RE: Case No. 2020-00242

ELECTRONIC APPLICATION OF UNBRIDLED SOLAR, LLC FOR A
CERTIFICATE OF CONSTRUCTION FOR AN APPROXIMATELY 160
MEGAWATT MERCHANT ELECTRIC SOLAR GENERATING FACILITY AND
NONREGULATED ELECTRIC TRANSMISSION LINE IN HENDERSON AND
WEBSTER COUNTIES, KENTUCKY

Review and Evaluation of Unbridled Solar LLC Site Assessment Report

Review and Evaluation of Unbridled Solar LLC Site Assessment Report

Figure C-1, Surrounding Communities Map.

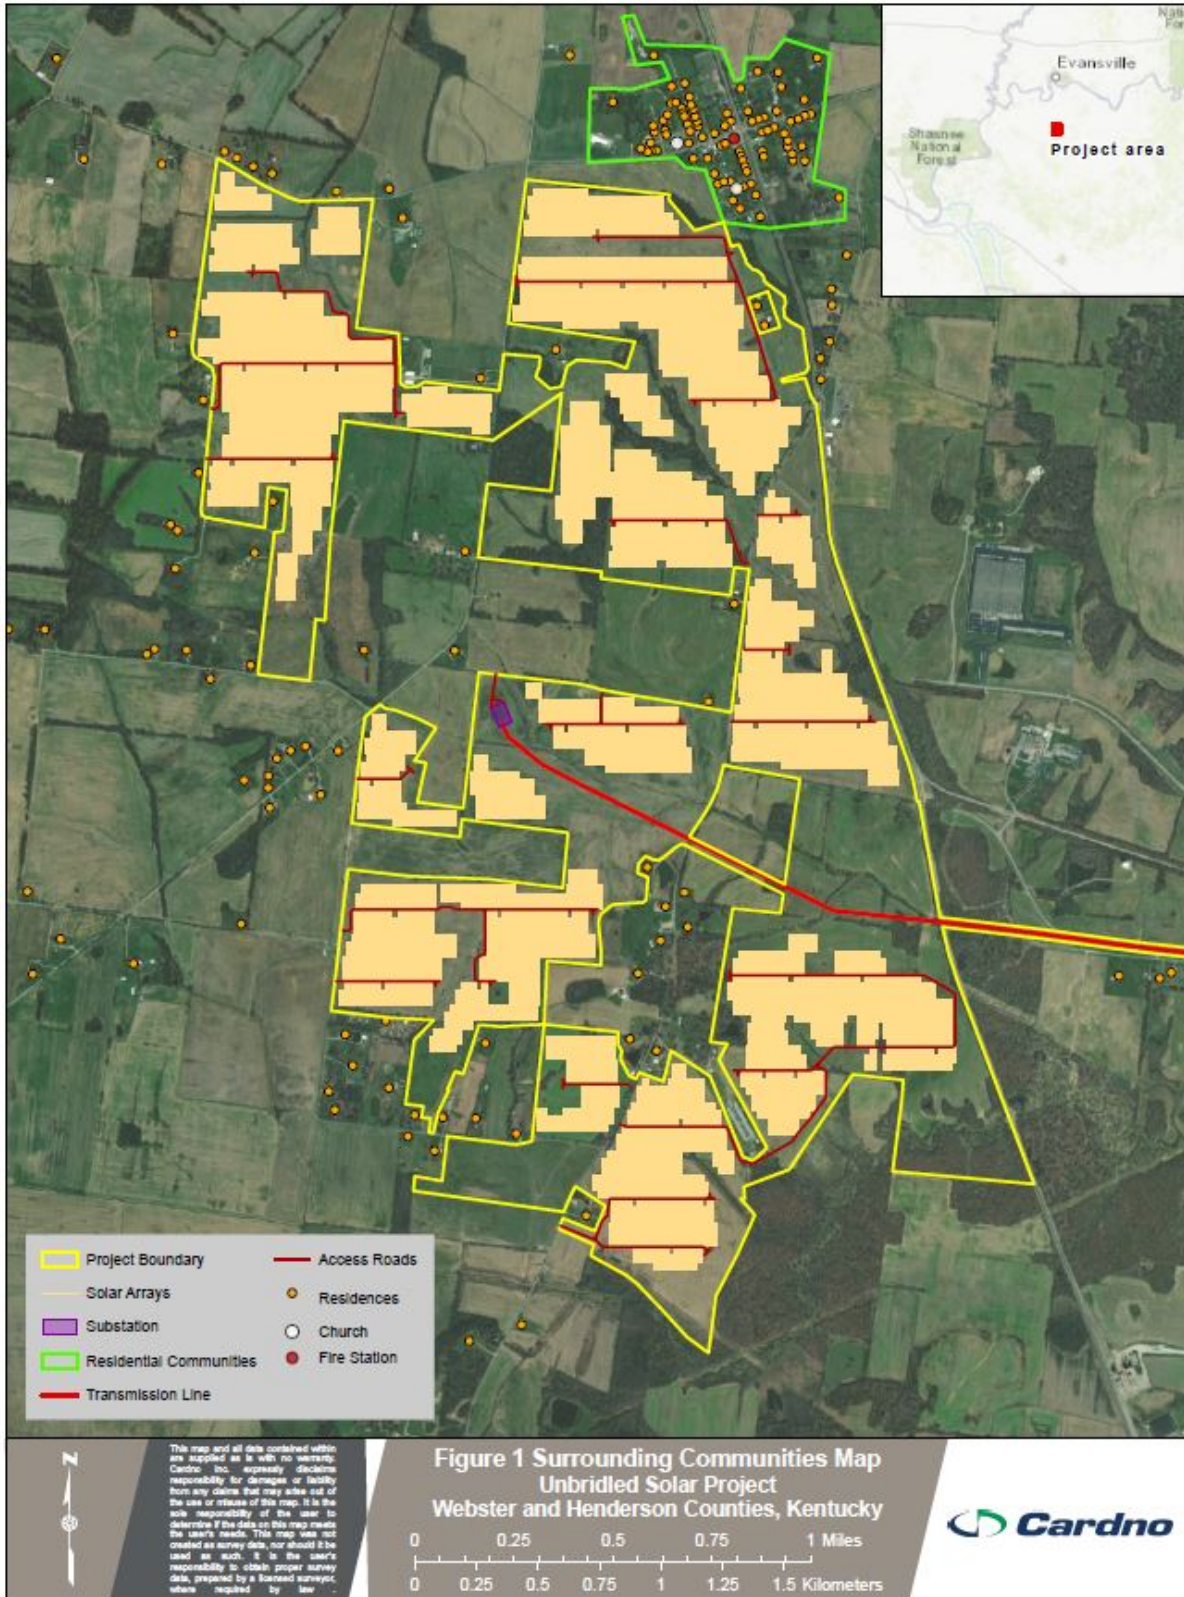
Other pertinent information about surrounding land uses includes the proximity of residential communities and community buildings. Figure C-1, excerpted from the applicant’s SAR, provides an aerial view of the proposed site, with the project boundary outlined in yellow. Residential communities, individual residences, and other notable features are depicted according to the figure legend provided.

Beyond dots showing the location of homes within two miles, and churches/fire stations and schools as noted above, the figure does not delineate surrounding land uses in terms such as agricultural land, residential land, commercial land, recreational land and industrial land.

Figure C-2, Surrounding Communities Map.

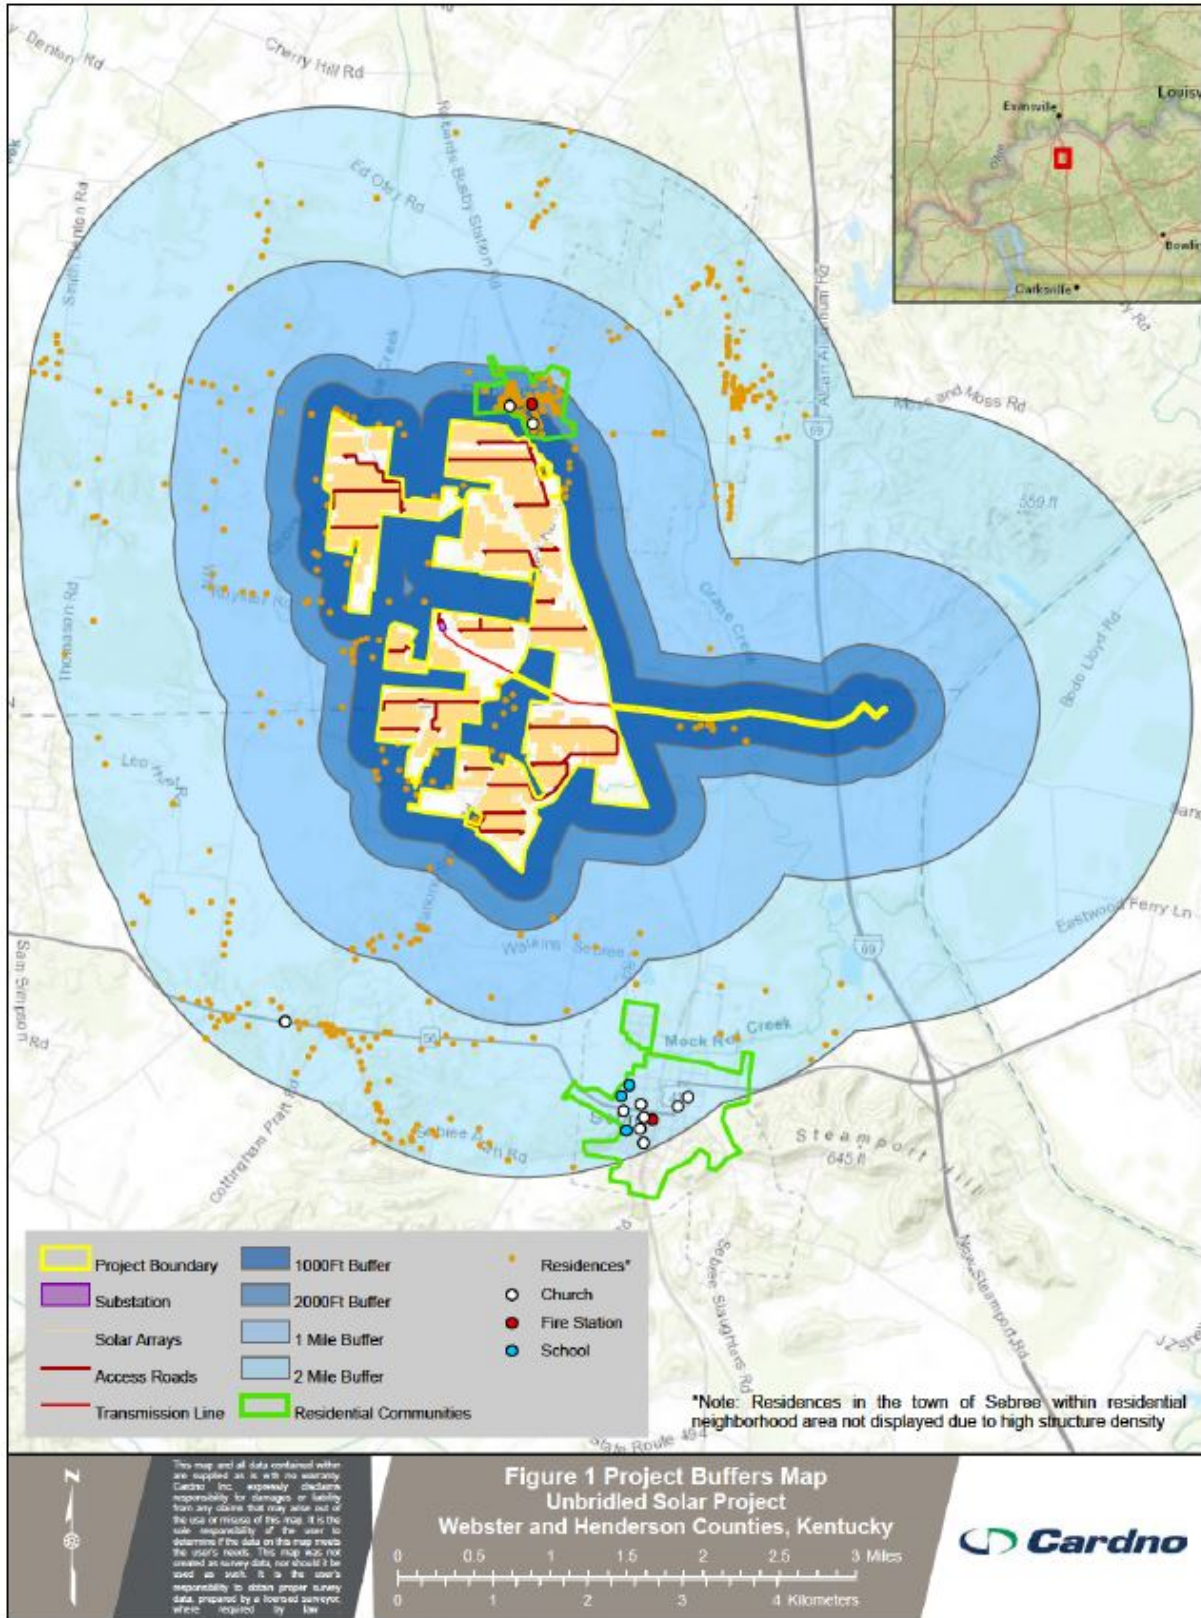
The figure shows a “Residential Community” partly within 1000 feet and nearly entirely within 2000 feet of the site on the northeast corner in Henderson County (the Town of Robards). Based on the figure, two churches and one fire station are located within Robards and are within approximately 1000 feet of the site.

The dotted county line, which runs east to west roughly through the middle of the proposed site, separates Henderson County (north) from Webster County (south). The figure depicts a second “Residential Community,” located in more distant proximity to the southeast corner of the site in Webster County. That community—the Town of Sebree—includes 7 churches, a fire station and 3 schools according to the figure. These features appear to be within two miles of the proposed site, but more than one mile away.

Figure C-3, Project Layout Map.

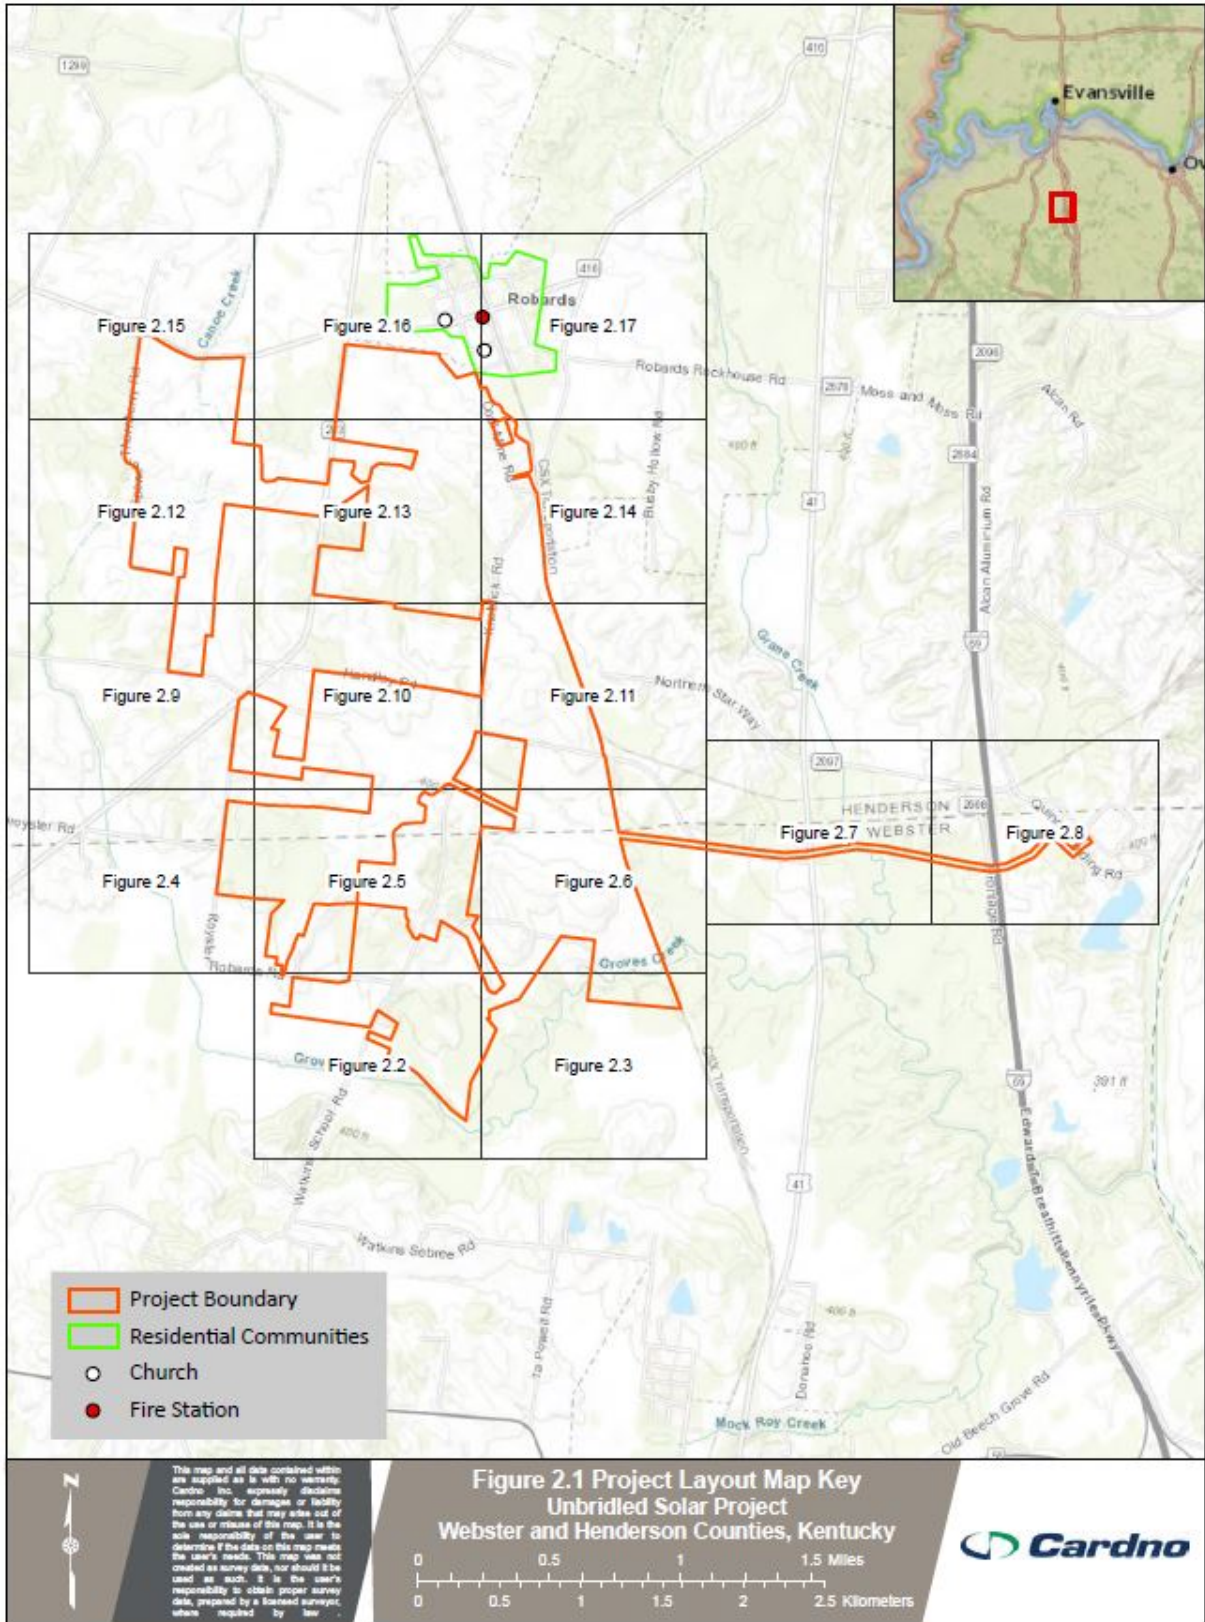
Access control. In response to the First Request for Information, Unbridled submitted an amended Exhibit K (Preliminary Site Plan), which was updated to include the locations of the anticipated 15 access points to the project. Access points occur on state and local roads and are distributed across the site and boundary.

Location and use of access ways, internal roads and railways. While the Unbridled SAR initially alluded to two points of access, the amended Exhibit K provided in response to the First Request for Information depicts a total of 15 access points across the proposed project site, as described above regarding access control.

Figure 2. 4 Star Industrial Park Parcels in Relation to Proposed Unbridled Solar Generating Facility and Transmission Line

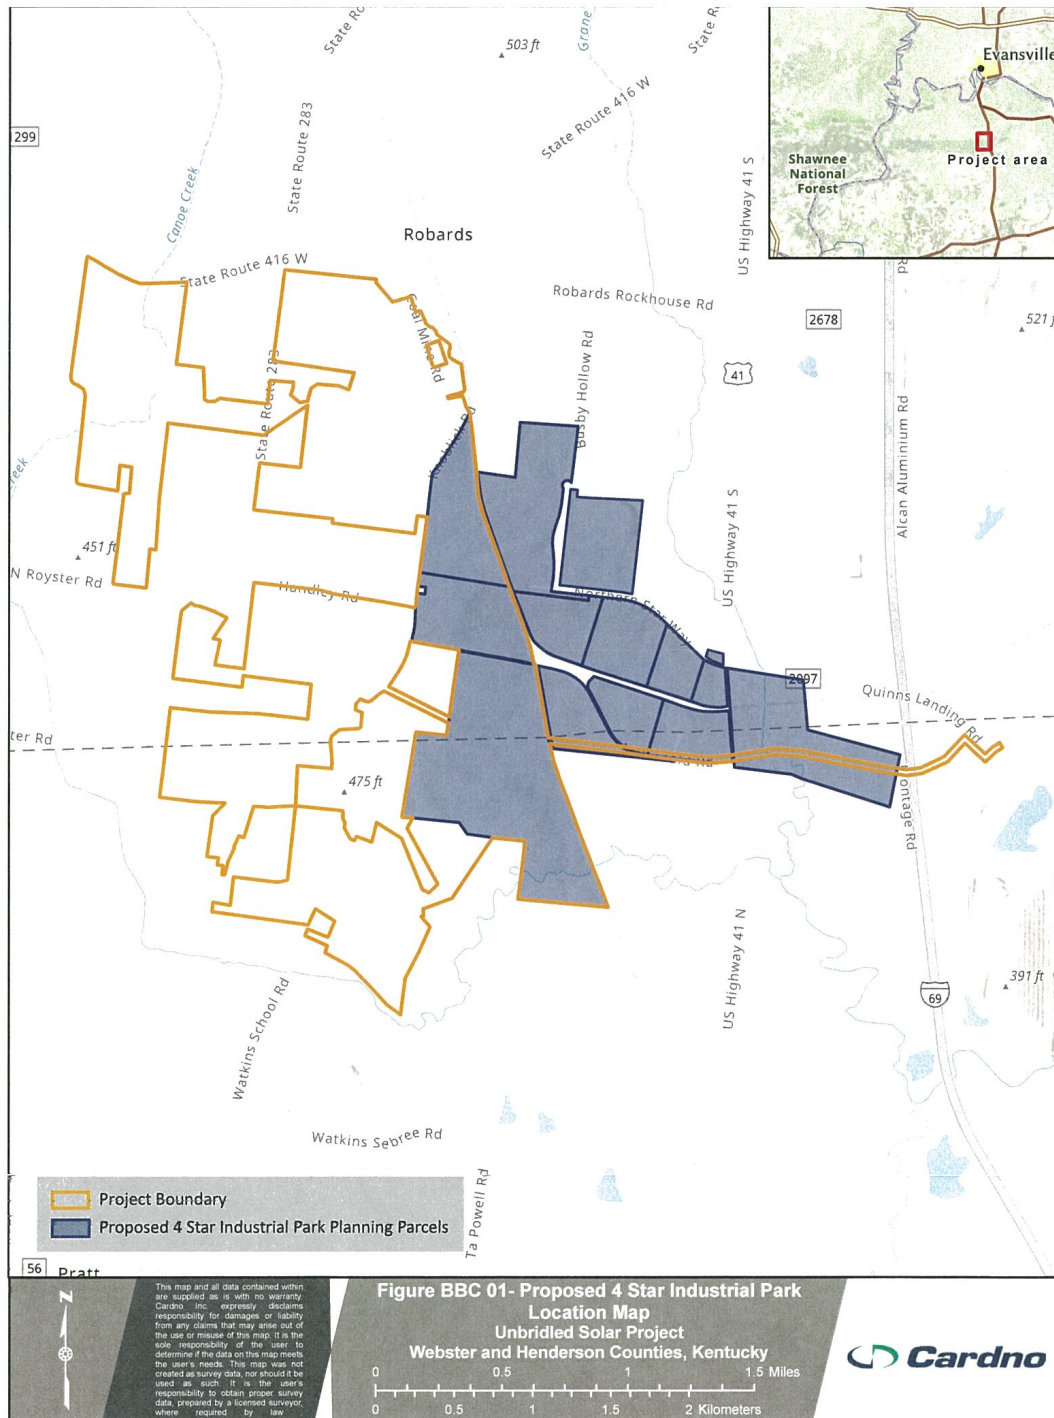
Nearly all of the selected route from the eastern edge of the proposed Unbridled Solar generating facility to the terminus at the Reid Substation is located on lands proposed for industrial use that lie within the Proposed 4 Star Industrial Park Planning Parcels, as shown in Figure 2 (copied from Unbridled Solar’s responses to questions posed the Public Service Commission staff and BBC on behalf of the Siting Board).

As noted previously, the most affected key observation points near the proposed transmission lines would likely be the six residences located within 500 feet south of the proposed line, west of U.S. Highway 41. Based on Figure 2 from Unbridled Solar's Application (also presented as Figure 1 in Section A of this report), as well as Figure 2.7 in Unbridled "Amended Exhibit J Figures" provided in response to the initial information request from the PSC and BBC, the right of way for the proposed route abuts the road separating those residences from the leased properties just north of them that the line would cross. In other words, it does not appear that the line could move any closer to those residences than already proposed without crossing onto their properties. Movement of the line to the north would benefit these nearby properties.
